COMANCHE PEAK STEAM ELECTRIC STATION
ENVIRONMENTAL REPORT OPERATING LICENSE STAGE
SEPTEMBER 1980 AMENDMENT
INSTRUCTION SHEET

CPSES/ER (OLS)

AMENDMENT 1
 SEPTEMBER 1980

FIGURE 3.3-2

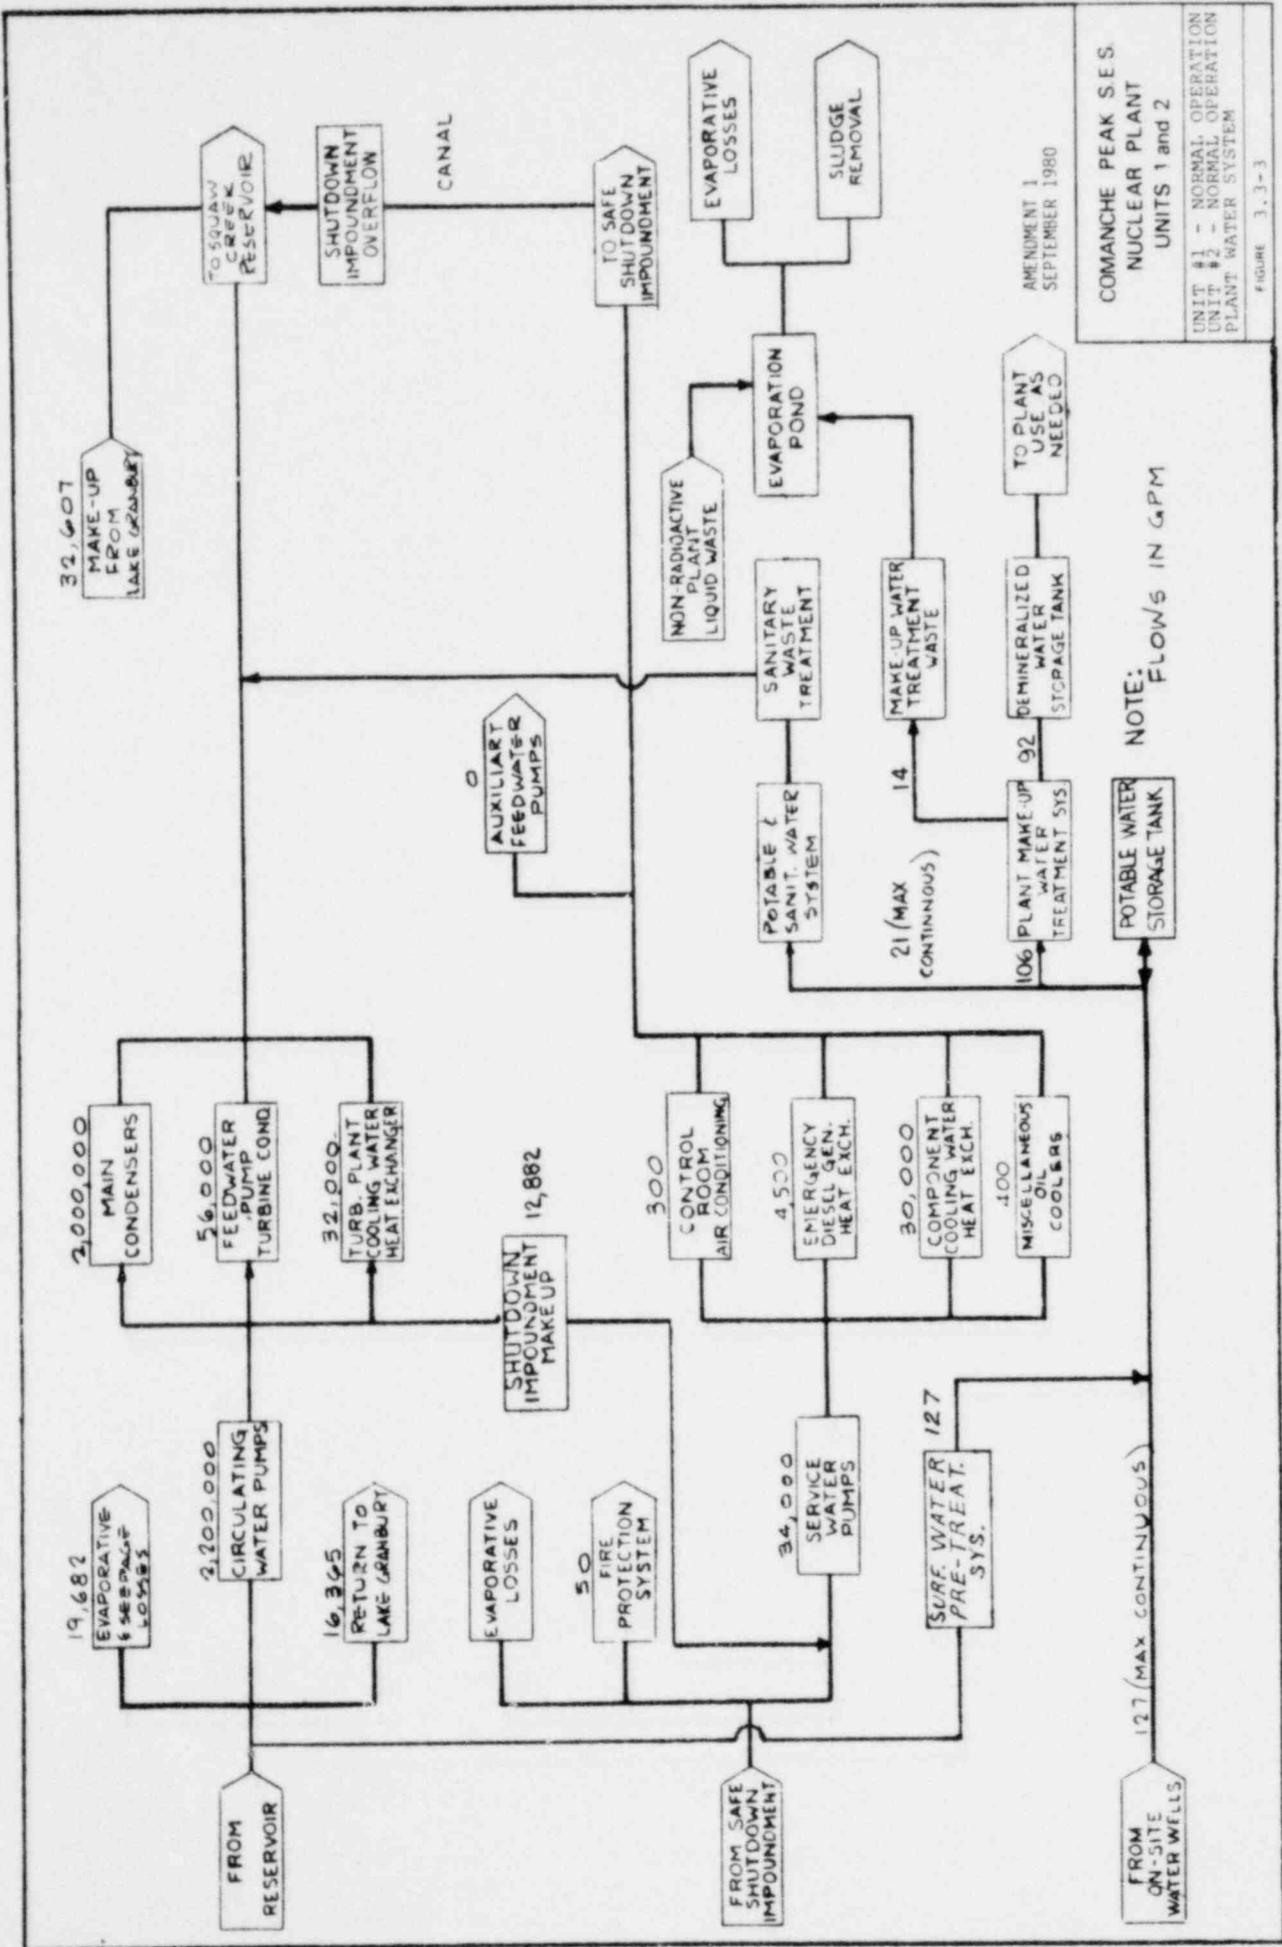
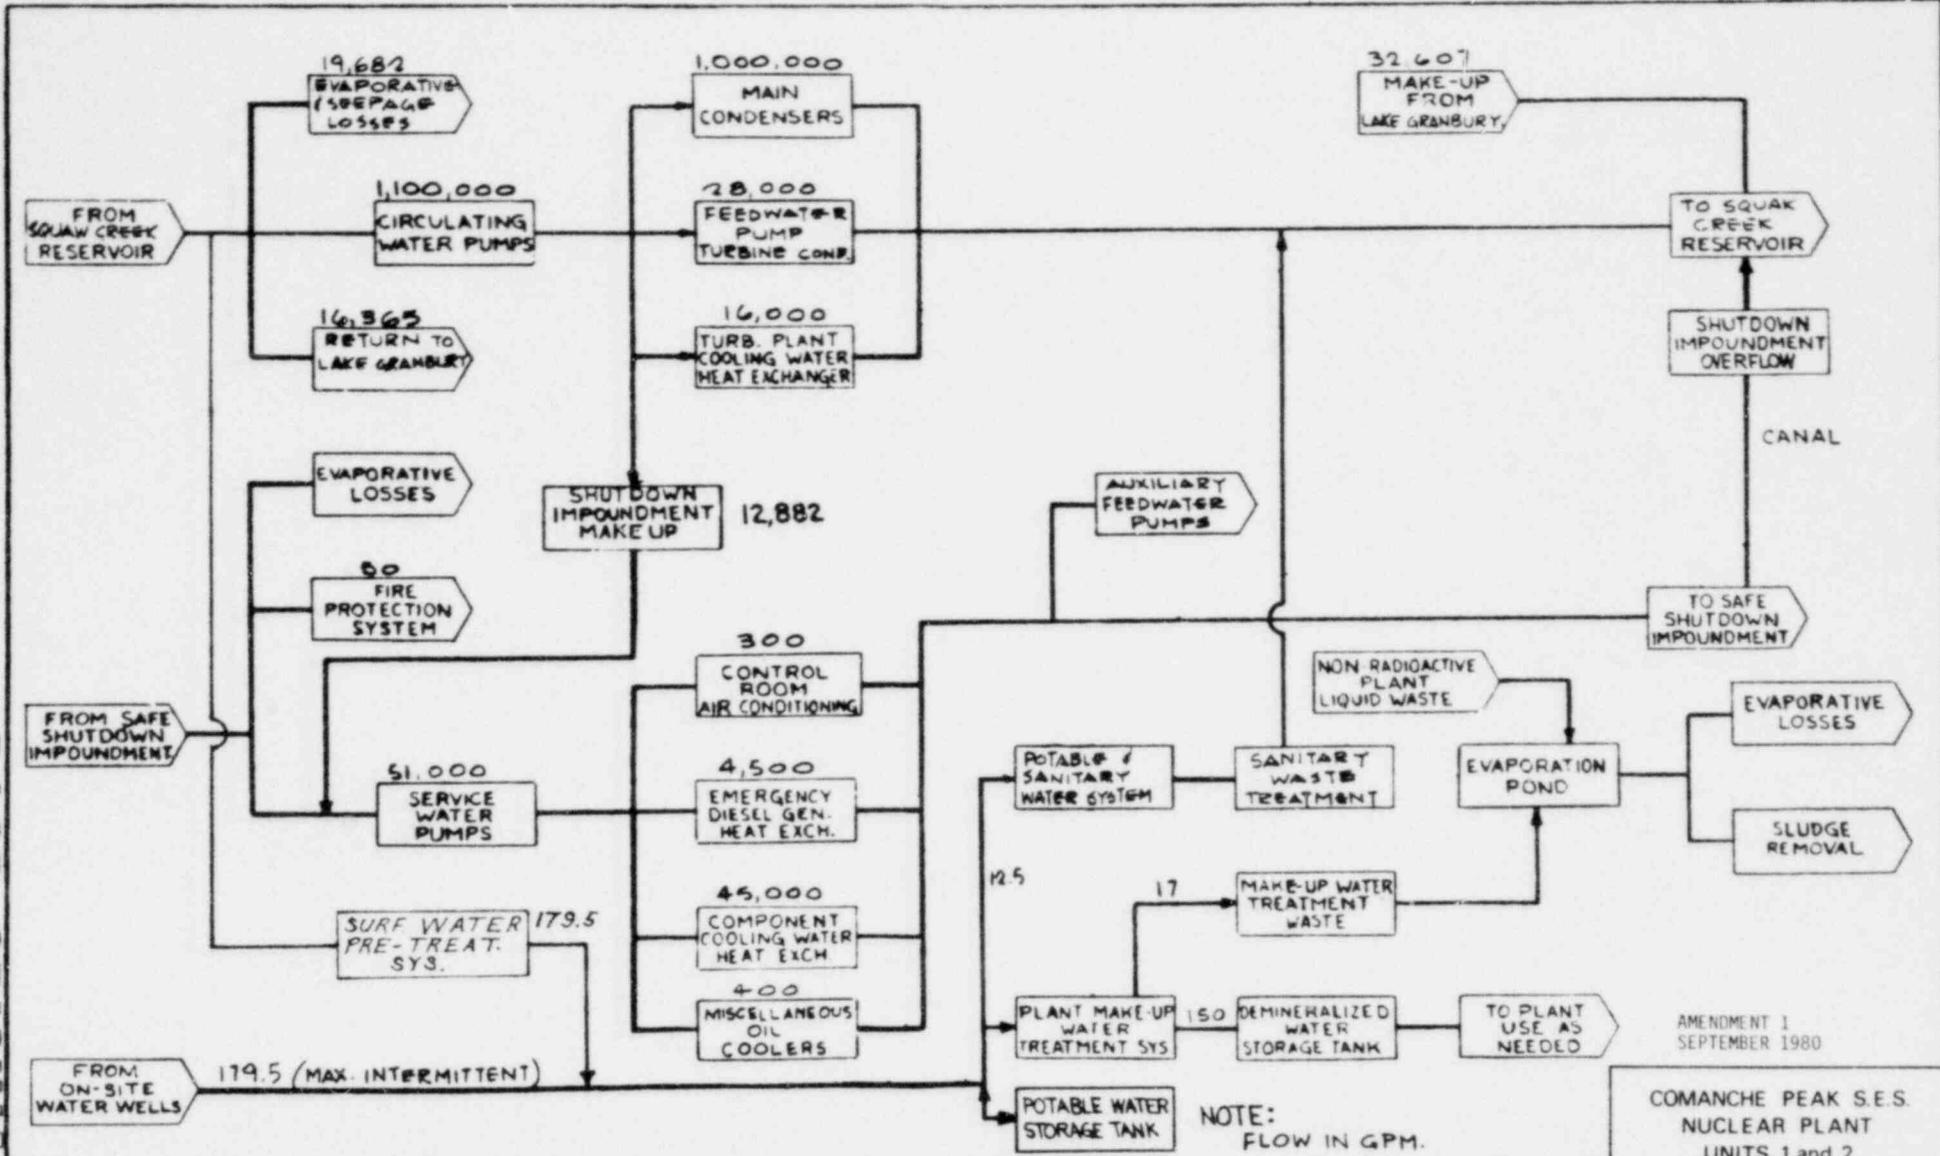
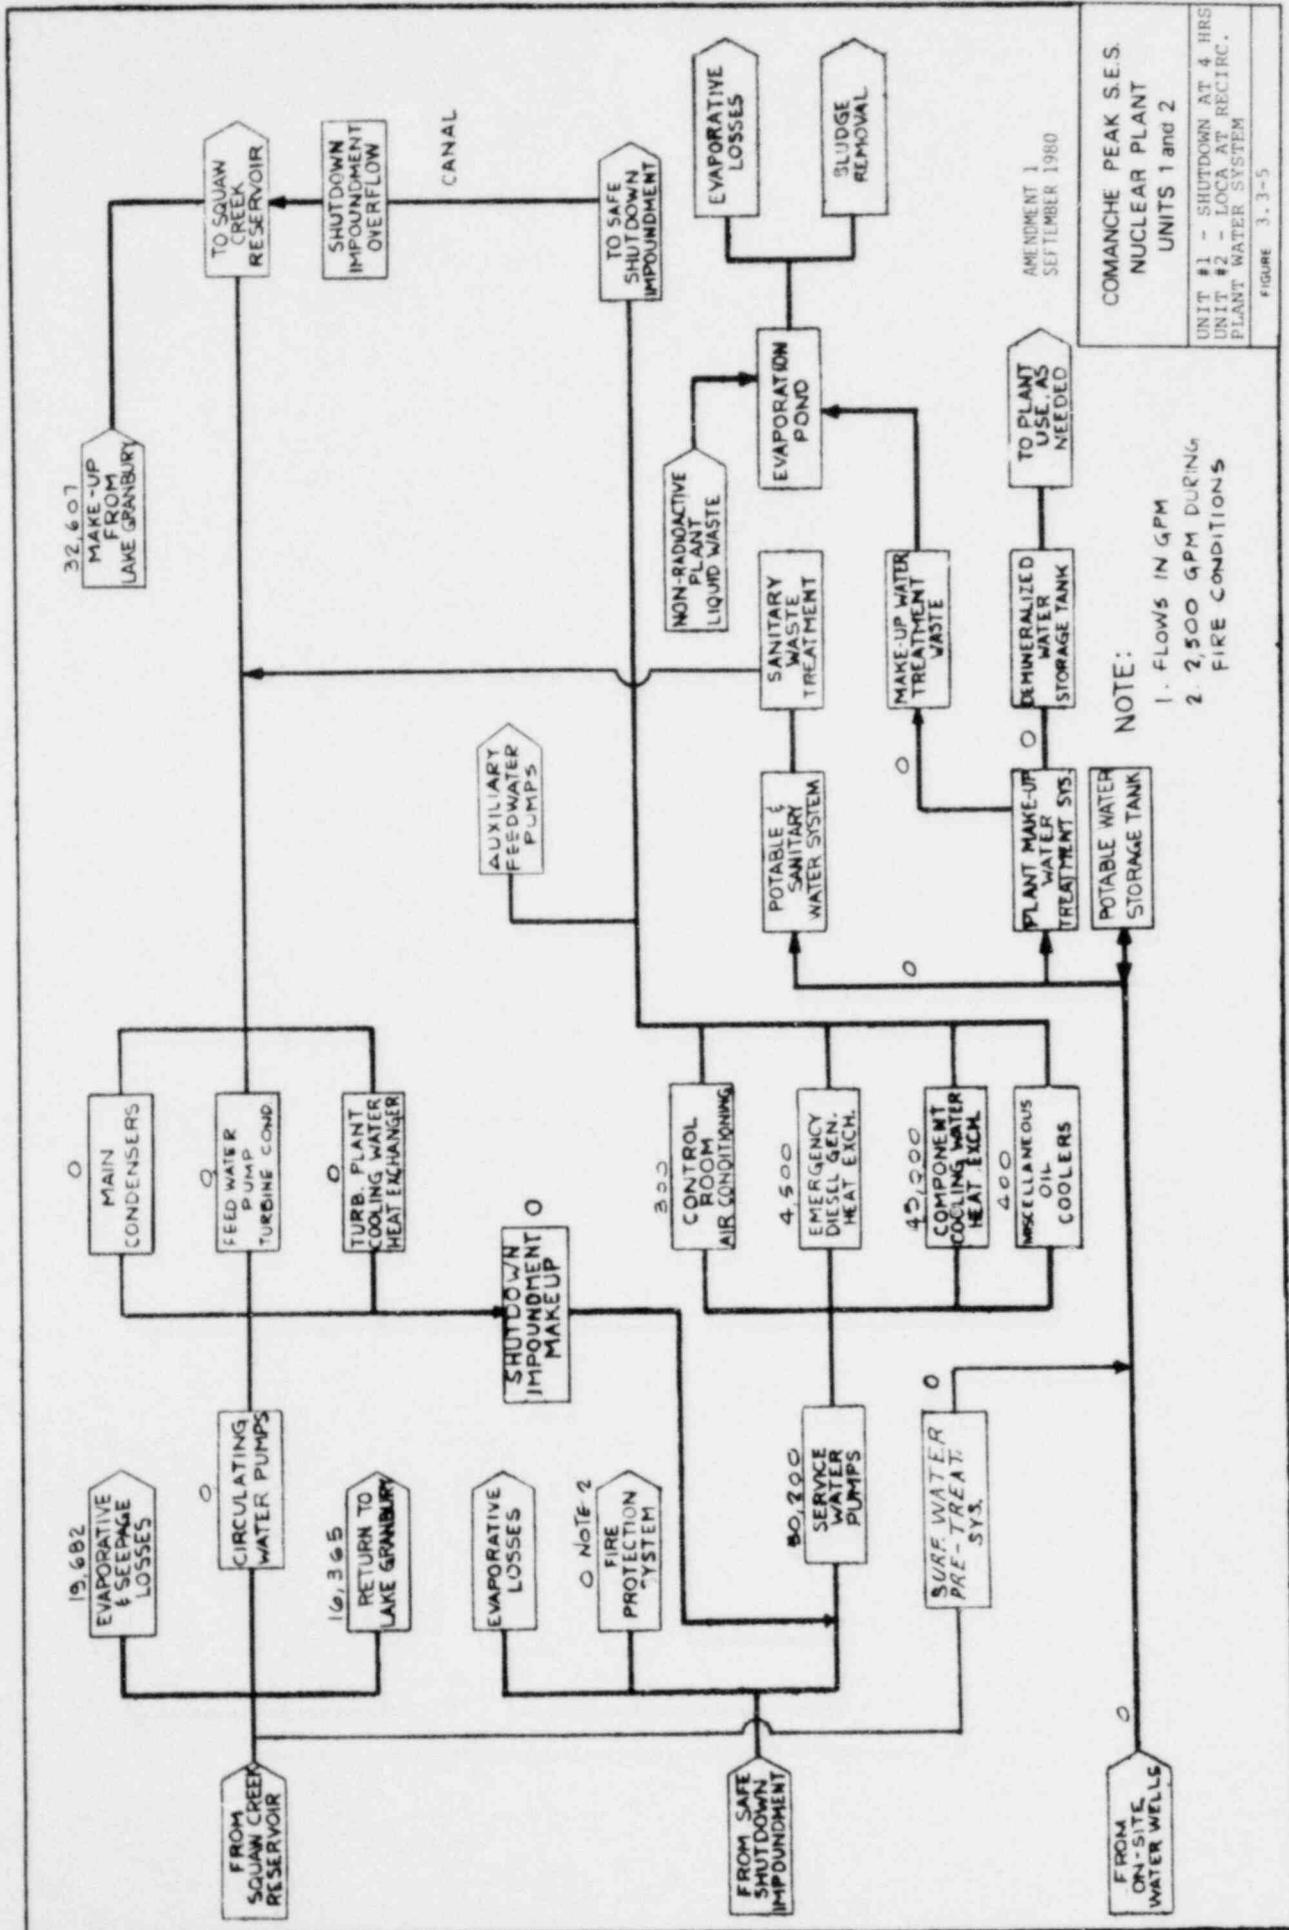
1 | Water is also required for in-plant process systems as well as for laundry, shower, sanitary, and drinking uses. This water is obtained from on-site wells. Water from the wells is filtered and chlorinated for potable uses and demineralized for use in the plant process system. Alternately, water is obtained from the surface water pre-treatment facilities which takes water from Squaw Creek Reservoir. The effect of drawdown due to operational pumpage will be minimized by supplemental supply from the reverse osmosis system. In-plant systems, including the primary system, the secondary system, the component cooling system, and other auxiliary and safeguard systems are closed, recirculating systems. The major continuing use of water in these systems is a small amount of makeup to replace leakage and drainage. These uses are illustrated in Figures 3.3-2 through 3.3-5.

The demineralizers which treat water for use in the various plant systems will periodically require substantial quantities of water and chemicals (acid and caustic) for regeneration. Non-radioactive effluents, except those from the heat dissipation system and treated sanitary effluent, are routed to the evaporation pond for disposal, as shown in Figures 3.3-2 through 3.3-5.

FIGURE 3 4 -5

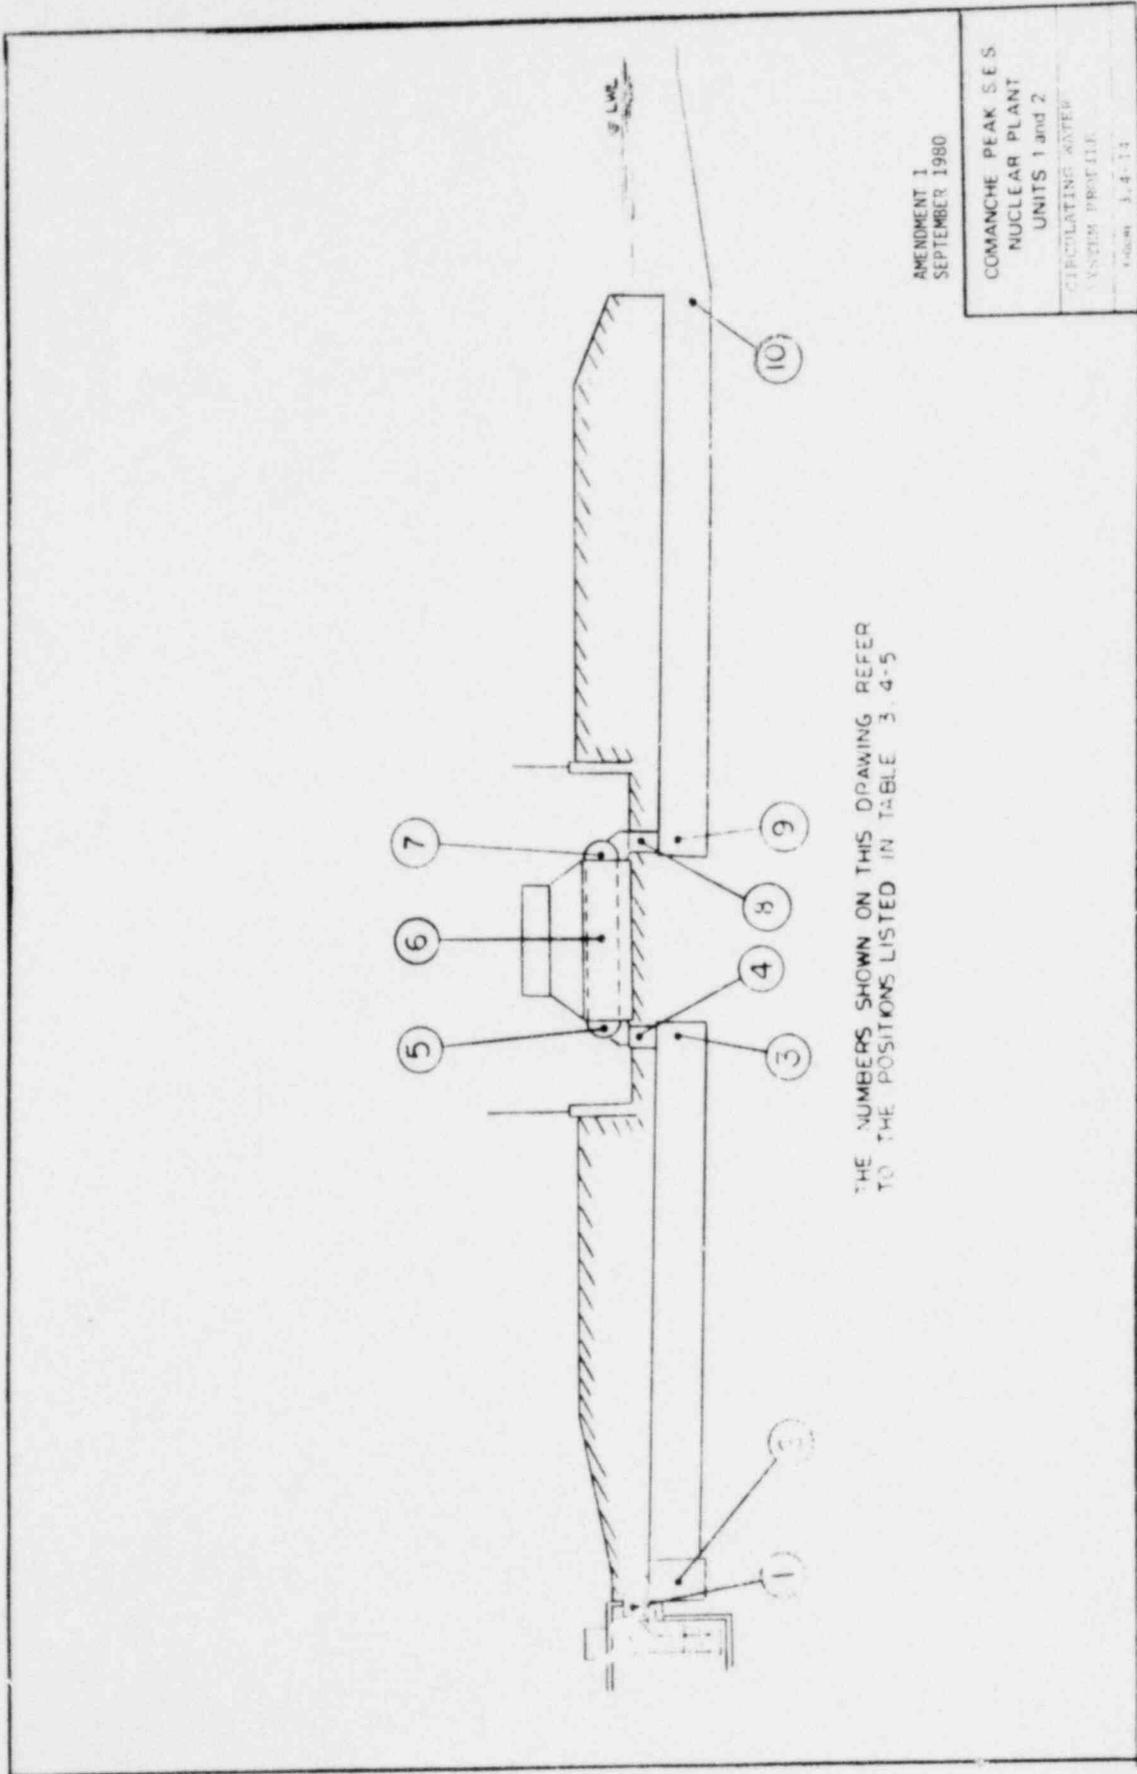
- Q55. ER-OL, page 3.4-5, Section 3.4.3.1. The circulating water system as presented in ER-CP has been modified at several locations including but not limited to the discharge tunnel and the discharge channel. However, the data presented in Table 3.4-5 in the ER-OL do not reflect these modifications. The position numbers given in the table do not correspond to the numbers shown on Figure 3.4-14 in the ER-OL. Several numbers mentioned on page 3.4-5 in the ER-OL describing the discharge channel design are also different from the numbers shown on Figure 3.4-5 in the ER-OL. Please clarify these discrepancies.
- R55. See revised Section 3.4.3.1, revised Table 3.4-5 and revised Figures 3.4-5 and 3.4-14.

- Q56. ER-OL, page 3.4-5, Section 3.4.3.1. Please provide a schematic diagram showing the design details of the discharge tunnels and also describe the material used for constructing the discharge channel floor.
- R56. See revised Section 3.4.3.1 and revised Figure 3.4-5.

Circulating water is pumped through the condenser where its temperature will increase approximately 15°F above the temperature at the intake. It is then routed back to the reservoir via one discharge tunnel per unit. These tunnels terminate in a submerged discharge structure, shown in Figure 3.4-5.

THE NUMBERS SHOWN ON THIS DRAWING REFER TO THE POSITIONS LISTED IN TABLE 3.4-5
